Access Compliance Report

Public Rights-of-Way

Intersection ID: 31083	Main Street: BROOKINGS_DR	Cross Street: TAUTEN_CT	Location:	N
ADA ID: CE89D2AF5055	Ramp Type: PerpDiag	Initial Pass/Fail: Fail	Overall Compliance: No	Severity Score: 8.75
Codes/Mitigation Info/Possible Solution		Field Measurements/Component Compliance

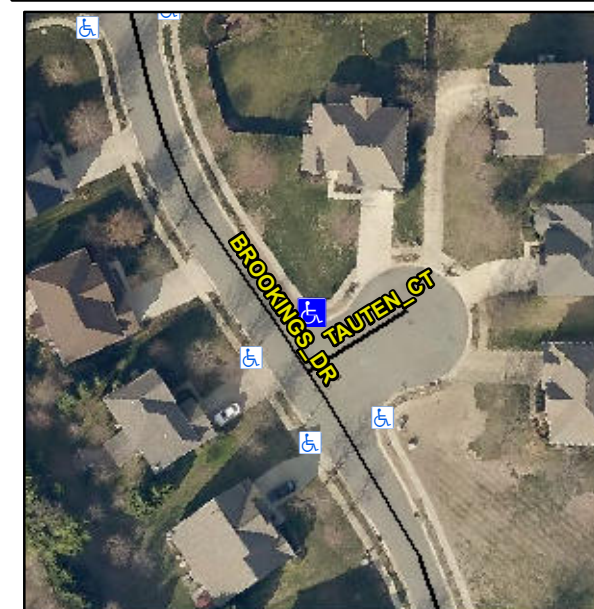
Compliance	Description	Data	Compliance	Description	Data
N/A	Ramp Length (in)	46.0	Yes	Ramp Slope (%)	7.0
No	Ramp Width (in)	44.0	Yes	Ramp XSlope (%)	0.9
N/A	Flare Type LT	N/A	N/A	Flare Type RT	N/A
N/A	Flare Slope LT (%)	N/A	N/A	Flare Slope RT (%)	N/A
N/A	Flare Traversable LT?	N/A	N/A	Flare Traversable RT?	N/A
N/A	Landing Length (in)	N/A	N/A	DWS Provided?	N/A
N/A	Landing Width (in)	N/A	N/A	DWS Contrast?	N/A
N/A	Landing Slope (%)	N/A	N/A	DWS Length (in)	N/A
N/A	Landing X Slope (%)	N/A	N/A	DWS Full Width?	N/A
N/A	Landing Curb? (Y/N)	N/A	N/A	DWS Offset (in)	N/A
N/A	Shared Landing?	N/A			
N/A	Gutter Ponding?	N/A	N/A	Gutter Slope (%)	N/A
N/A	Gutter Lip Ht (in)	N/A	N/A	Gutter X Slope (%)	N/A
N/A	Painted X Walk1?	No	N/A	Painted X Walk2?	No
	X Walk 1 Direction	To SW		X Walk 2 Direction	To SE
N/A	X Walk 1 Width (in)	N/A	N/A	X Walk 2 Width (in)	N/A
	X Walk 1 Slope (%)	1.4		X Walk 2 Slope (%)	1.9
	X Walk 1 X Slope (%)	2.1		X Walk 2 X Slope (%)	0.2

N/A	Ramp inside XWalk1?	N/A	N/A	Ramp inside XWalk2?	N/A
	Road Slope (%)	0.3	N/A	Clear Space?	N/A
	Road X Slope (%)	0.4	N/A	Clear Space to XWalk (in)	N/A
N/A	Any Obstructions?	N/A	N/A	Storm Grate/Utility Hazard?	N/A
	Obstruction Type			Storm Grate/Utility Type	
		N/A			N/A
			Yes	Surface Condition? (G/P)	Good

Remove & Replace Curb Ramp With Two New Directional Ramps or Equivalent.
